ECE/TRANS/WP.29/GRE/2009/14  
16 January 2009

**REGULATION No. 37**  
**(Filament lamps)**

**Proposal for Supplement 34 to the 03 series of amendments**

**Submitted by the expert from the Working Party "Brussels 1952" \*/**

" Sheet HS5A/1  
**CATEGORY HS5A**  
The drawings are intended only to illustrate the essential dimensions (in mm) of the filament lamp

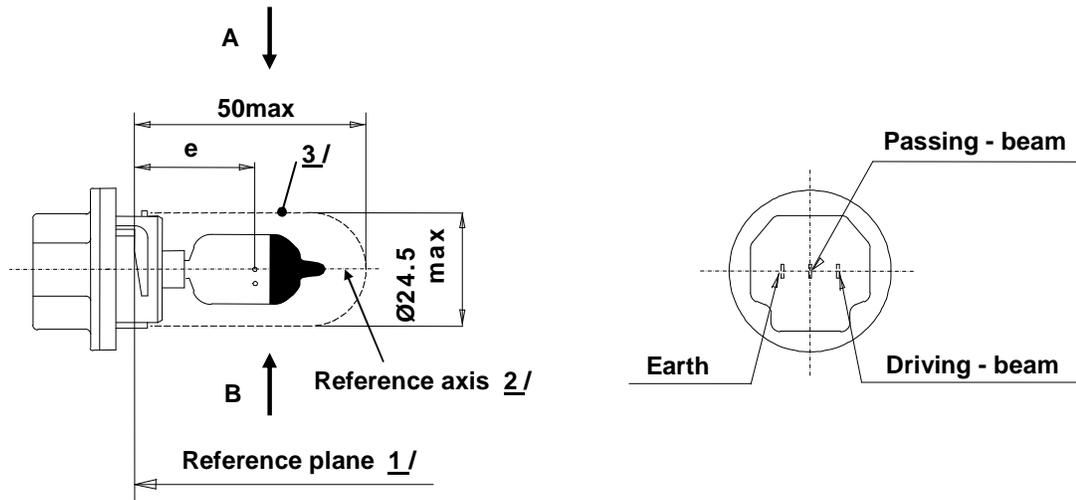
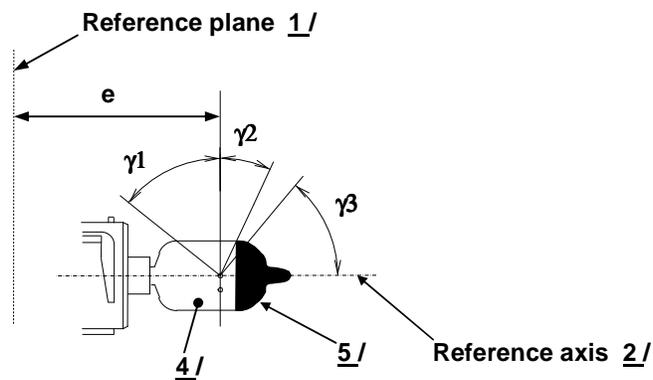
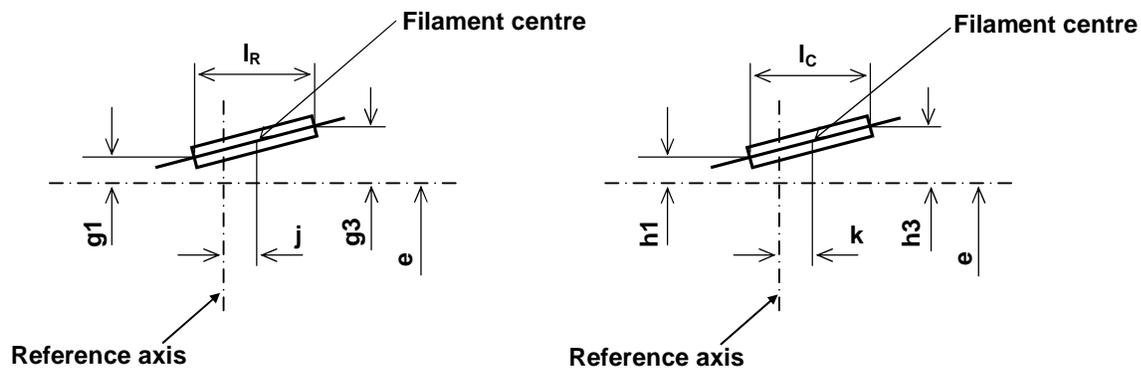
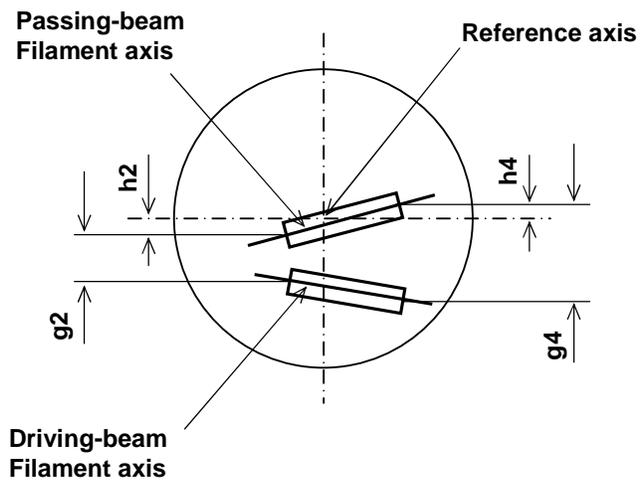
Insert new sheets HS5A/1 to 3, between sheet HS5/4 and sheet HS6/1, to read (see next pages):
